IMPORTANT SAFETY RECALL

Subject: Safety Recall Campaign: NHTSA #13V-508

Involving: Big Tex Trailer Manufacturing, Inc. Model 10PI, 12PI, 14PI, 29SA, 30AA, 30LS, 30SA, 30SV, 35AA, 35LS, 35SA, 35SV, 45LA, 45SS, 50LA, 50SA, 60SP, 70LR, 70PI, 70SP and 70TV Trailers

SERVICE ALERT: Fold Flat Ramp Gate Latch System	
SCOPE:	10PI, 12PI, 14PI, 29SA, 30AA, 30LS, 30SA, 30SV, 35AA, 35LS, 35SA, 35SV, 45LA, 45SS, 50LA, 50SA, 60SP, 70LR, 70PI, 70SP, 70TV
PURPOSE:	To install enhanced ramp gate latch brackets
TOOLS and COMPONENTS REQUIRED:	Retrofit Kit (see "Enclosed Kit Parts" illustration) 2 ea 3/4" wrenches 2 ea 9/16" wrenches 2 ea 7/16" wrenches
PROCEDURE:	<div data-bbox="175 913 678 1249">A close-up photograph of the existing ramp gate latch system on a trailer. It shows a metal bracket with a bolt and nut assembly attached to a vertical support post.</div> <div data-bbox="175 1276 678 1612">A photograph showing a person's hand using a wrench to remove a bolt from the latch system. A red arrow points to the bolt being removed.</div> <div data-bbox="175 1640 667 1967">A close-up photograph of the new enhanced ramp gate latch bracket being installed on the vertical support post. The bracket ha

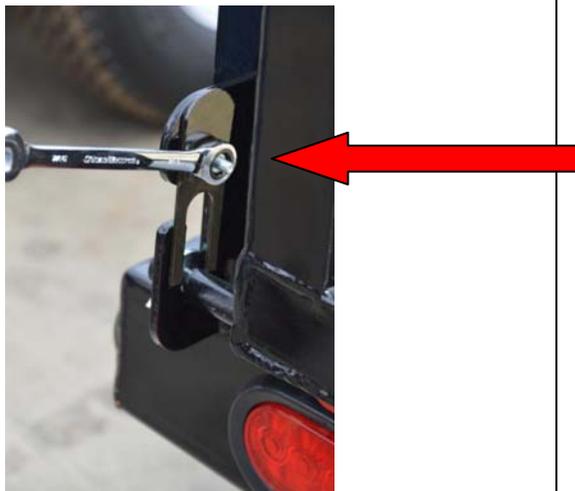
6. Insert ramp swivel ear into bracket assembly with the washers provided in your kit on both sides of swivel ear. Insert the new $\frac{1}{2}$ " x 1-3/4" bolt (F) and snug the lock nut.

7. Install the two bolts (E) on the inboard side of the bracket. Place nut to rear of ramp gate and tighten.
8. Place Ramp Gate Caution Sticker (K) directly above new ramp gate bracket.

9. Ensure rubber washer (H) installed on ramp pin. Spare Washers provided in kit.

10. On the ramp gate hinge, ensure that hinge keeper (C & D) is installed on trailer. Remove the existing nut and install lock nut (G) provided. Should the keeper have two holes, please ensure that bolt is through the bottom hole on the keeper.
11. Repeat procedure on second side of trailer. After the retrofit is complete, inspect all hardware to ensure it is tight and secure.
12. Notify Warranty Department (warranty@bigtextrailers.com) to update Master List once service procedure has been completed.

Enclosed Kit Parts

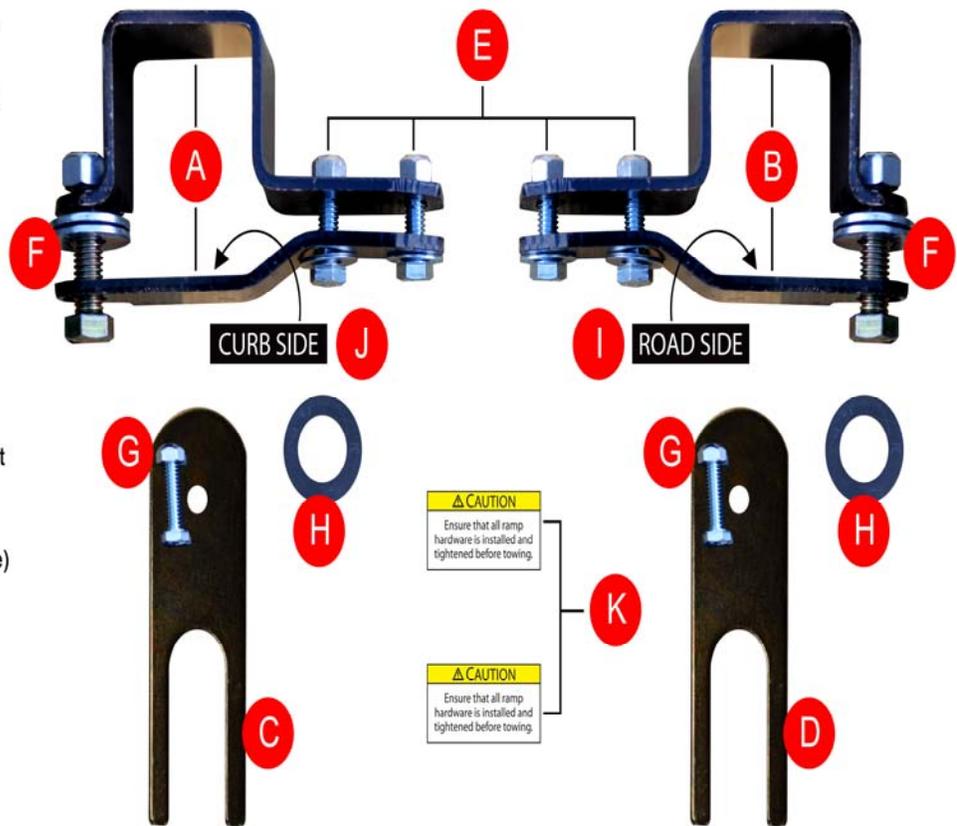
- A. Ramp Gate Latch Bracket, Two-Piece (Curb Side)
- B. Ramp Gate Latch Bracket, Two-Piece (Road Side)
- C. Hinge Keeper (Curb Side)
- D. Hinge Keeper (Road Side)
- E. 3/8" x 1-1/4" Bolts w/ Washer & Lock Nut (2 Ea Per Side)
- F. 1/2" x 1-3/4" Bolt w/ Washers (2) & Lock Nut (1 Ea Per Side)
- G. 2 Ea 1/4" x 1" Bolt w/ Lock Nut (1 Ea Per Side)
- H. 2 Ea Rubber Washer (1 Ea Per Side)
- I. Road Side Sticker
- J. Curb Side Sticker
- K. 2 Ea Caution Stickers (1 Ea Per Side)
